THE LAND COURT OF QUEENSLAND

File Numbers: MRA082-13 & EPA083-13

Applicant: **HANCOCK COAL PTY LTD (ACN 130 249 973)**

JOINT EXPERTS REPORT ON GROUNDWATER

Figure: 12a

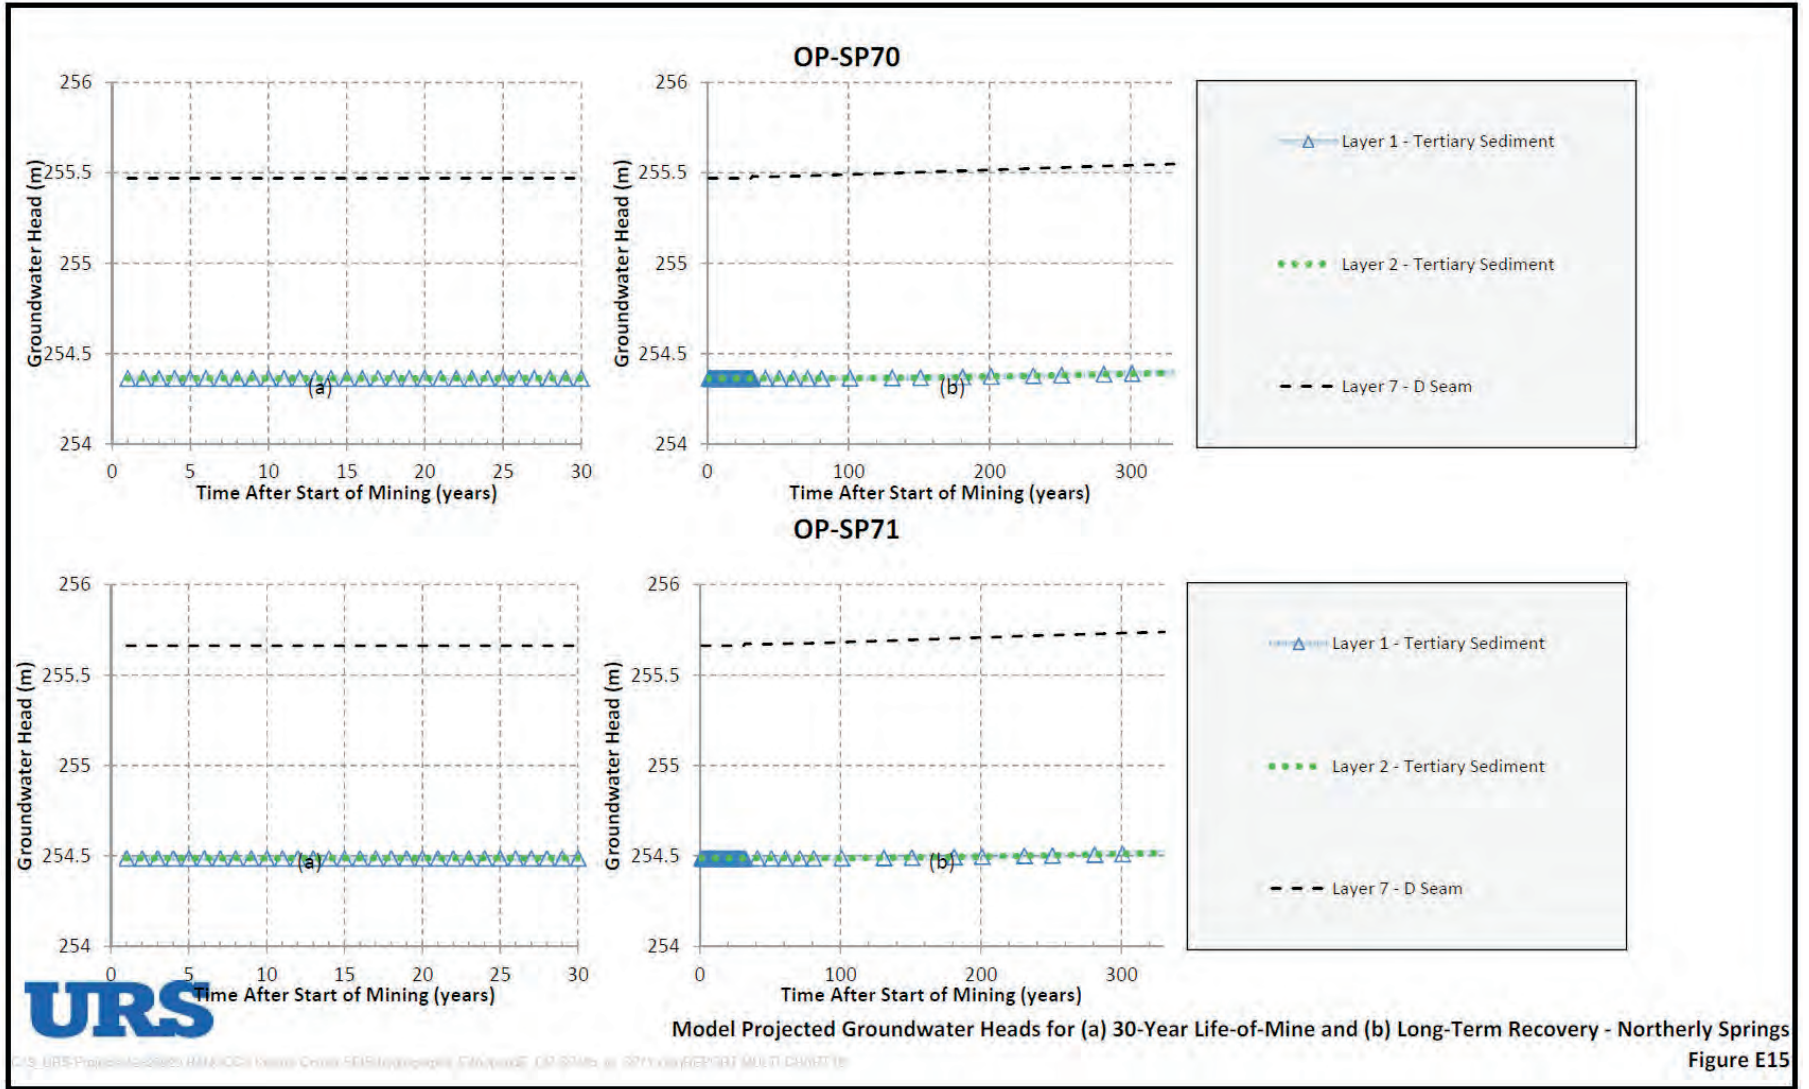
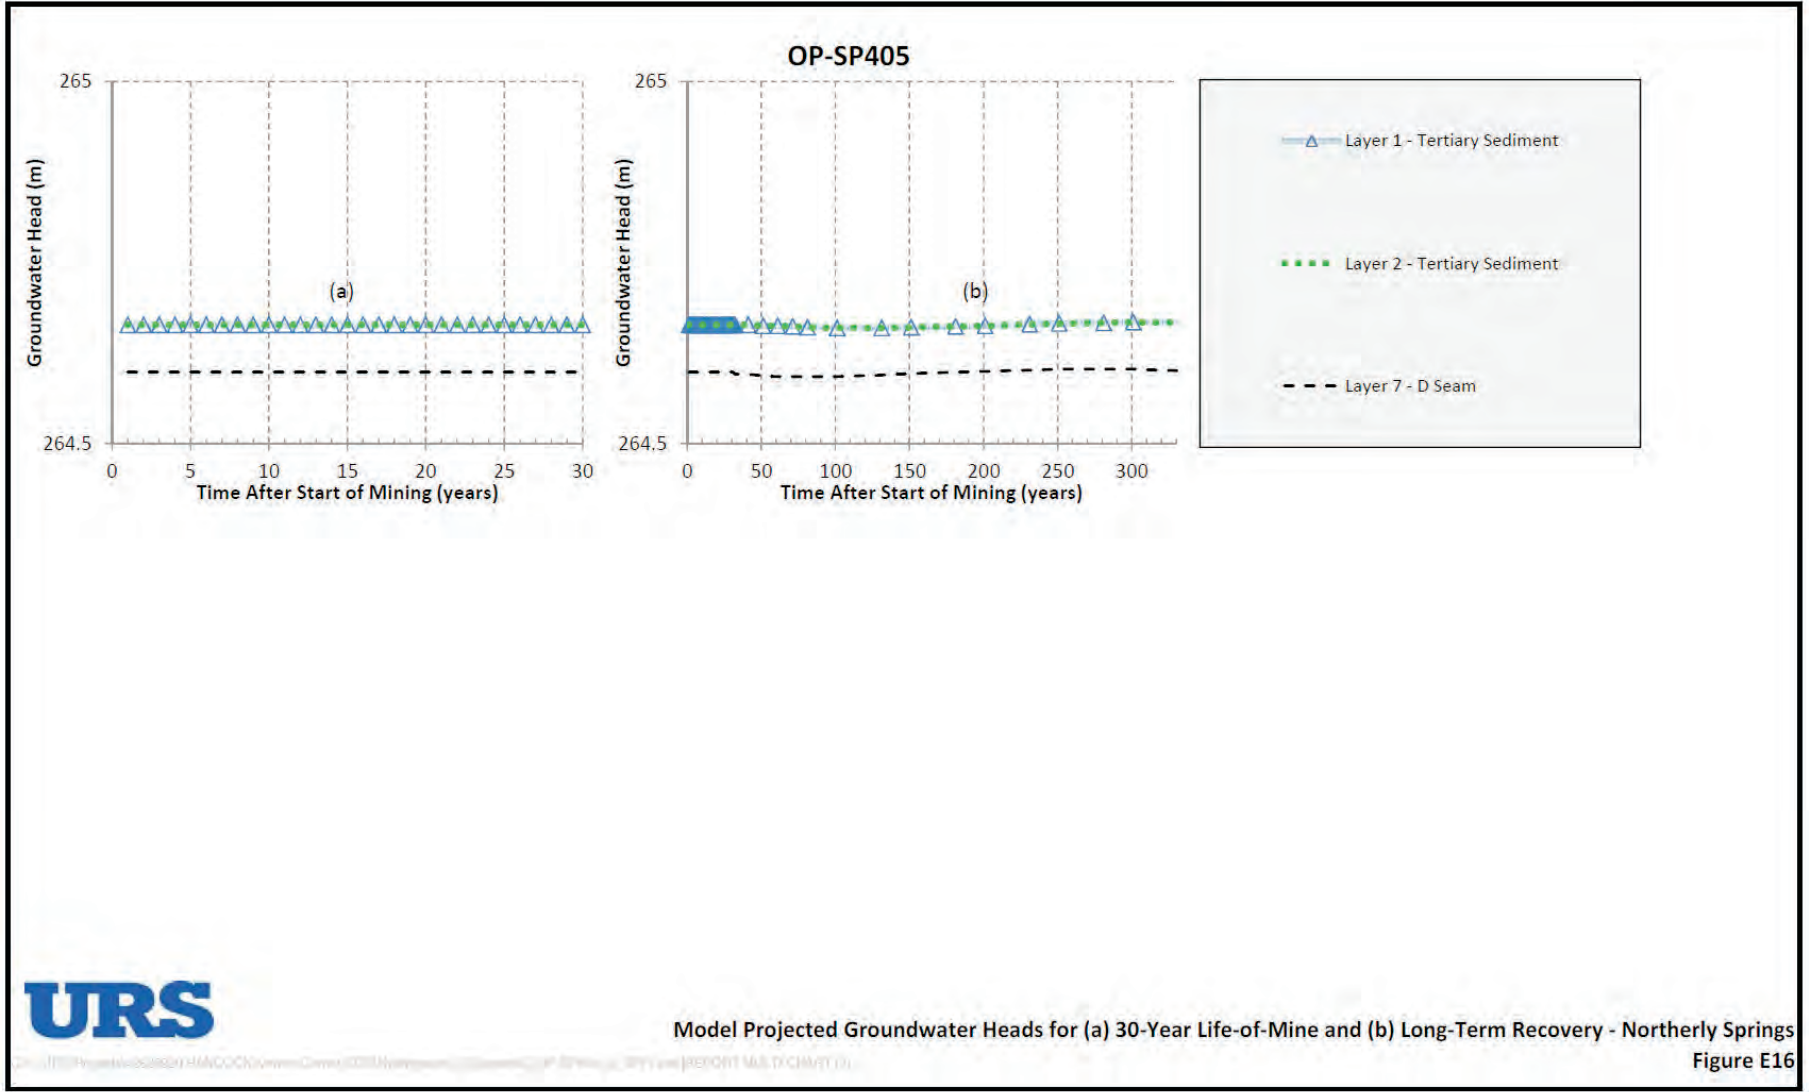
199. Groundwater level data for the Tertiary overburden (Layer 1), Tertiary sediments (Layer 2), and the target D seam was projected over time (30 years life of mine and 300 years post mining). The Tertiary layers were assumed to be saturated and have the same initial heads as the steady-state calibration. No change in groundwater levels (Appendix A Figure 12a and Figure 12b), in any of the model layers, was predicted.

Appendix B Dr Gavin Mudd Figures

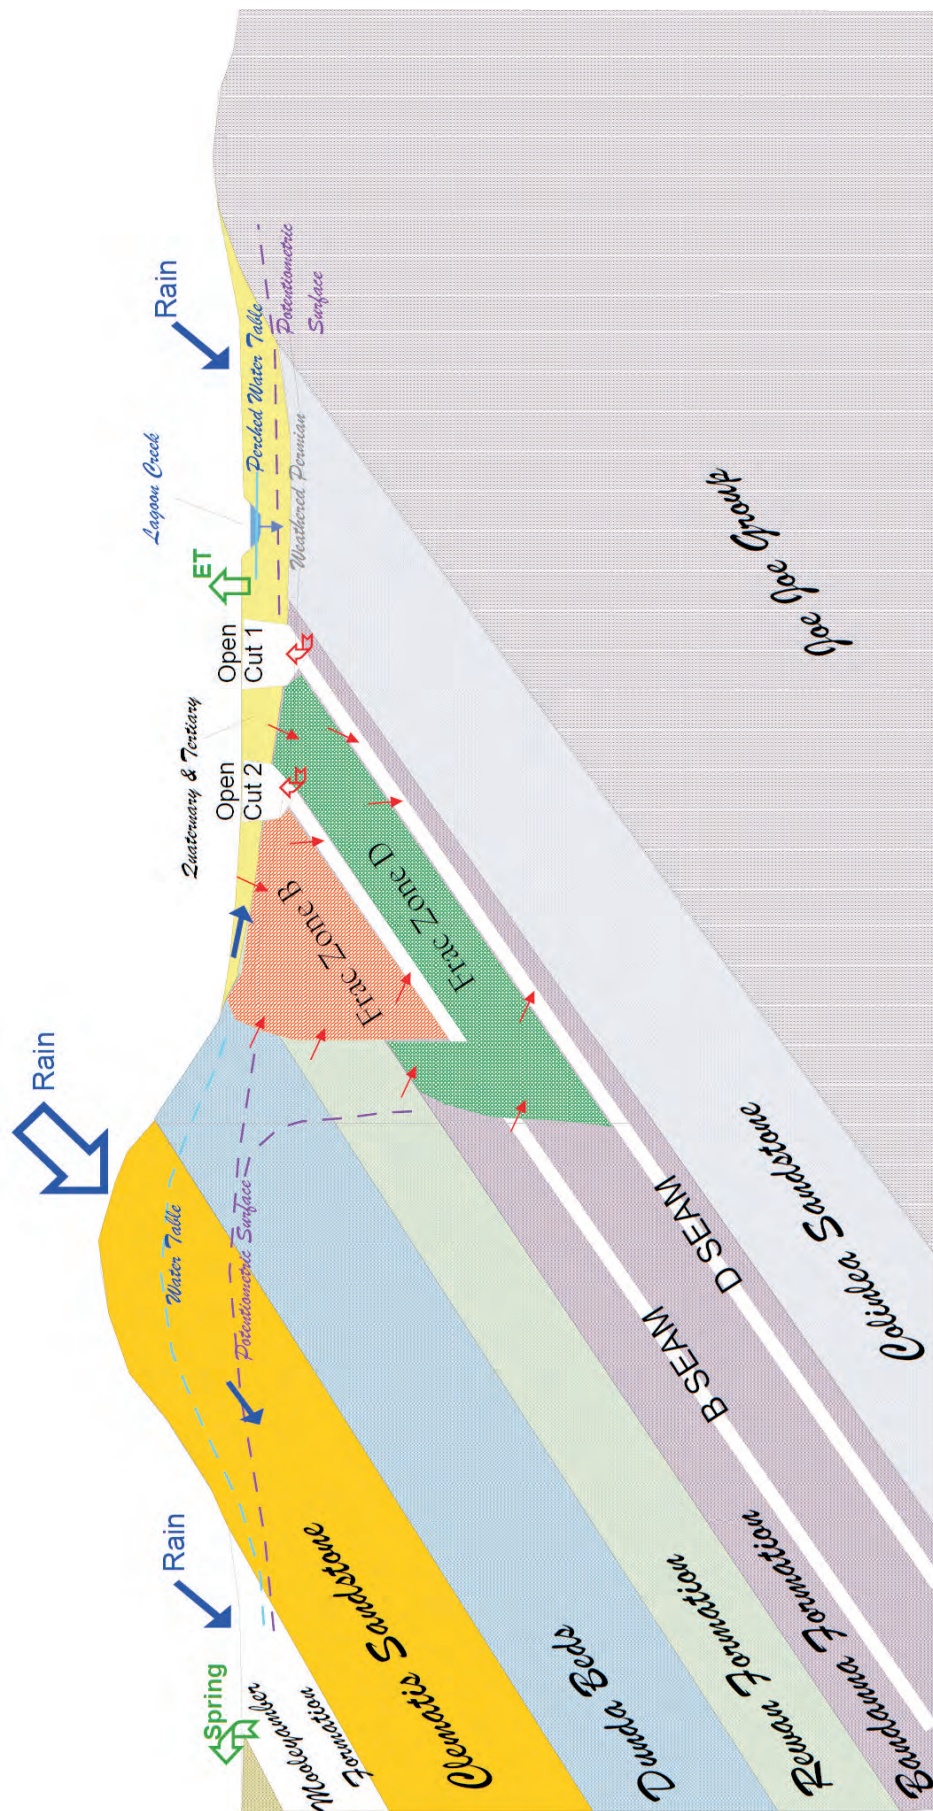
103. Western boundary of the groundwater model a no flow boundary to simulate a groundwater divide. Dr Mudd questioned the western boundary, arguing it was most likely a constant head, as shown by the Waratah SEIS conceptual groundwater model used for the numerical modelling study in that study (Appendix B Figure 1).

geological structure and how this relates to the observed groundwater pressures. I maintain the view that the GDR is effectively a constant head boundary, as presented in the Waratah Galilee SEIS and shown in Appendix B Figure 1. It is my view that further field work is required to validate the geological controls on groundwater along the GDR and the interactions between the GDR, Galilee Basin and the Great Artesian Basin groundwater system to the west.
